Access Compliance Report

Public Rights-of-Way

Intersection ID: 53534	Main Street: N_JOSH_BIRMINGHAM_PY	Cross Street: WILKINSON_BV	Location: NE
ADA ID: AC02B945B107	Ramp Type: Perp	Initial Pass/Fail: Fail	Overall Compliance: No
Codes/Mitigation Info/Possible Solution			Severity Score: 10
			Field Measurements/Component Compliance

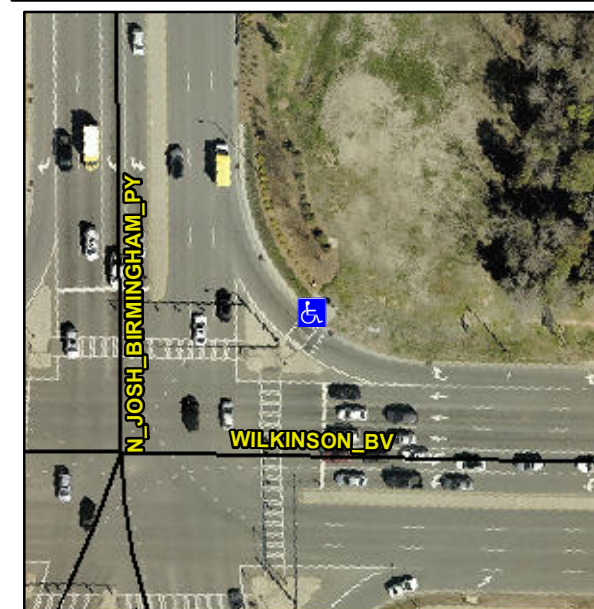
Not Found, R304.5.1, R304.5.3

Compliance	Description	Data	Compliance	Description	Data
N/A	Ramp Length (in)	67.0	Yes	Ramp Slope (%)	7.9
No	Ramp Width (in)	47.0	No	Ramp XSlope (%)	2.5
N/A	Flare Type LT	N/A	N/A	Flare Type RT	N/A
N/A	Flare Slope LT (%)	N/A	N/A	Flare Slope RT (%)	N/A
N/A	Flare Traversable LT?	N/A	N/A	Flare Traversable RT?	N/A
N/A	Landing Length (in)	N/A	N/A	DWS Provided?	N/A
N/A	Landing Width (in)	N/A	N/A	DWS Contrast?	N/A
N/A	Landing Slope (%)	N/A	N/A	DWS Length (in)	N/A
N/A	Landing X Slope (%)	N/A	N/A	DWS Full Width?	N/A
N/A	Landing Curb? (Y/N)	N/A	N/A	DWS Offset (in)	N/A
N/A	Shared Landing?	N/A			
N/A	Gutter Ponding?	N/A	N/A	Gutter Slope (%)	N/A
N/A	Gutter Lip Ht (in)	N/A	N/A	Gutter X Slope (%)	N/A
N/A	Painted X Walk1?	Yes	N/A	Painted X Walk2?	N/A
	X Walk 1 Direction	To SW		X Walk 2 Direction	N/A
N/A	X Walk 1 Width (in)	111.0	N/A	X Walk 2 Width (in)	N/A
	X Walk 1 Slope (%)	2.2		X Walk 2 Slope (%)	N/A
	X Walk 1 X Slope (%)	3.0		X Walk 2 X Slope (%)	N/A

Remove & Replace Entire Ramp.
